Quality Control Check Report. Stage: After Finishing Stage III (Apartments)

MAYFLOWER PLATINUM

Details of Additions & Alterations

Flat No	608	Block no.	'A'
Flat Area	1800 sft	Type	Deluxe / Luxury
Buyer Name	K Vindhya Kumari/K Prabhakar		
Phone No.	9849708495/9848413222	Email	K.Prabhakar@gmail.com

Description	Direction	Owners & Developers :	Date :	18.03.2020	Promoted by
WORKING DRAWING OF FLAT.NO.A-8	N	Modi Properties Pvt Ltd.	Prepared By :		Modi Properties Pvt. Ltd
		Project Name & Phase :	Approved By :	Soham Modi	Phone:+91-40-66335551
		MAYFLOWR PLATINUM	Scale :	N.T.S

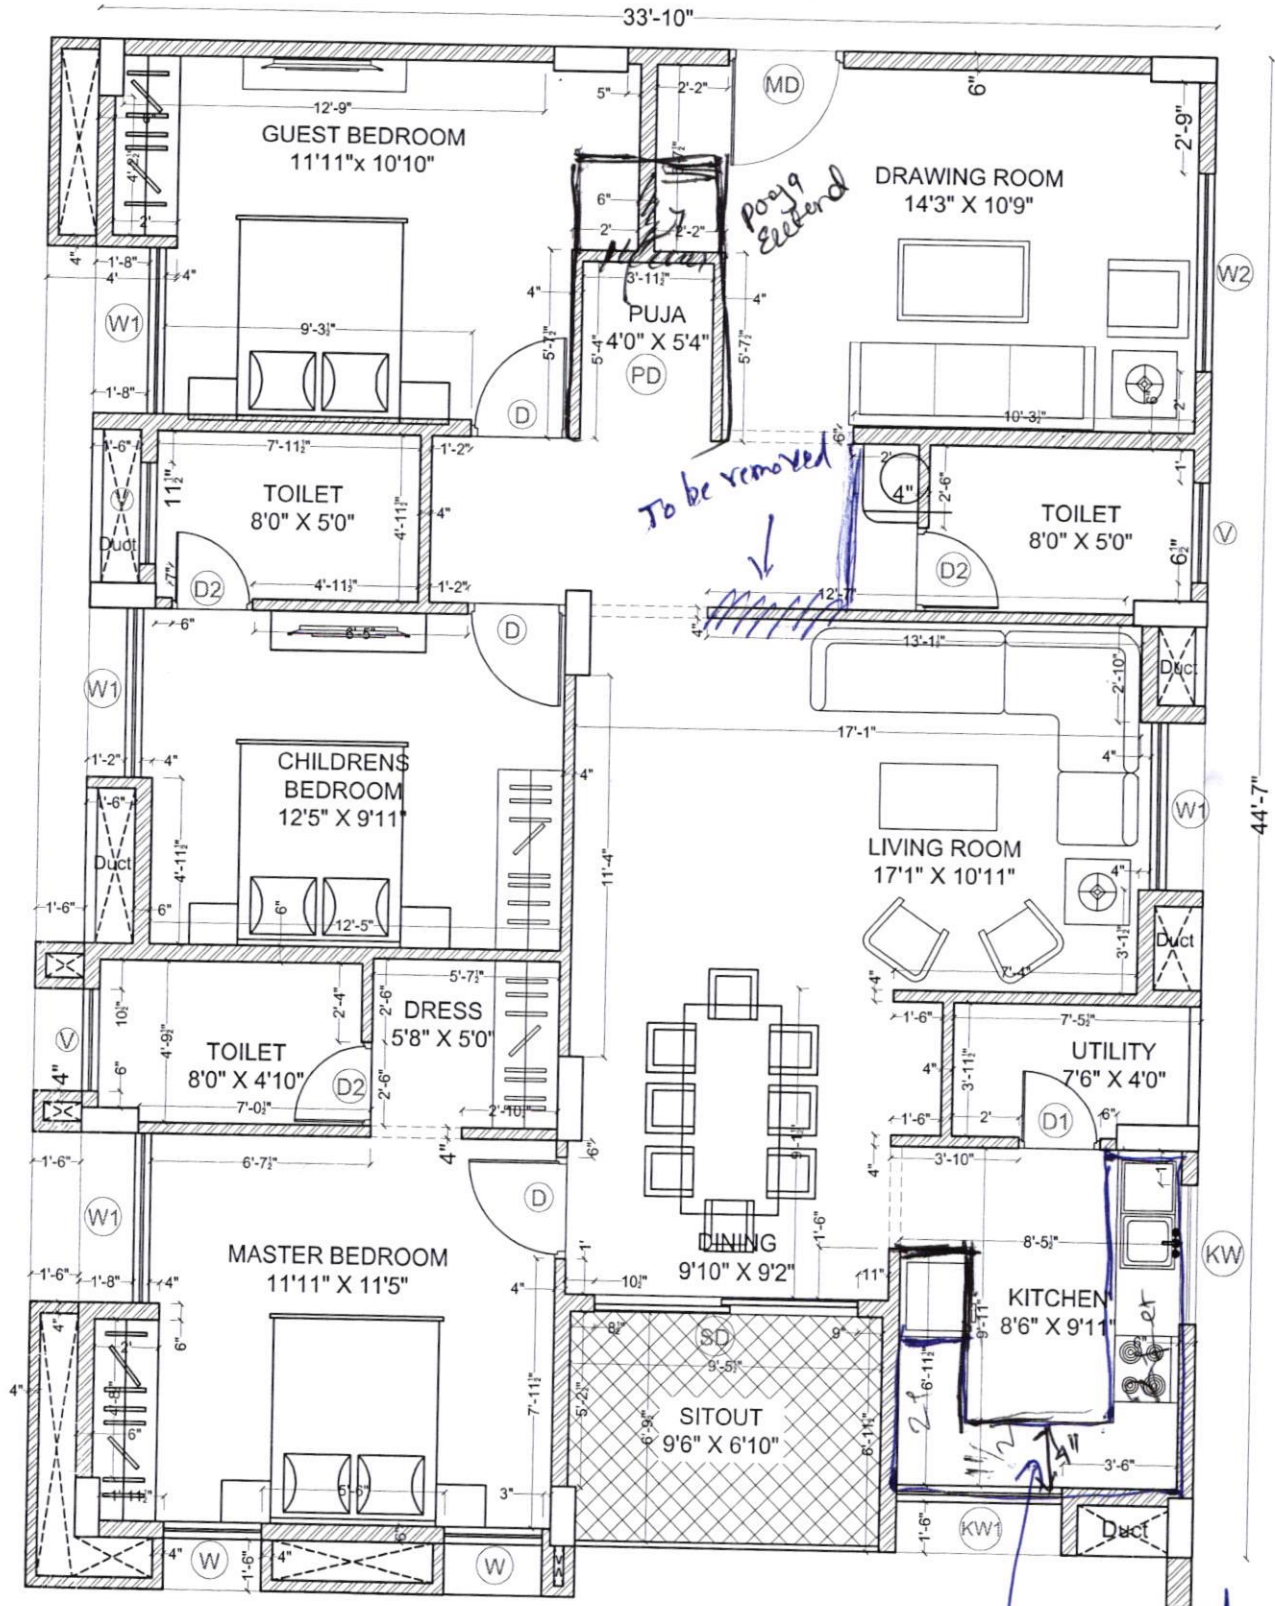
Changes in electrical points: (mark on plan)

- ① Shift 6 way pt marked on plan
- ② All bedrooms - fan regulator & switch two way pt
- ③ night lamp provision in all bedrooms above 1st floor.

- ① Wash Basin pt outside common toilet (marked on plan)
- ② common bathroom tiles same as remaining ~~C.B.R~~ bathrooms. MBR same as model flat A106.

Changes in kitchen platform: (mark on plan)

① Kitchen platform extra modular kitchen
(marked on plan)

② RCC slab - U shape marked on plan.

③ RCC slab height should be 29" flat finish.
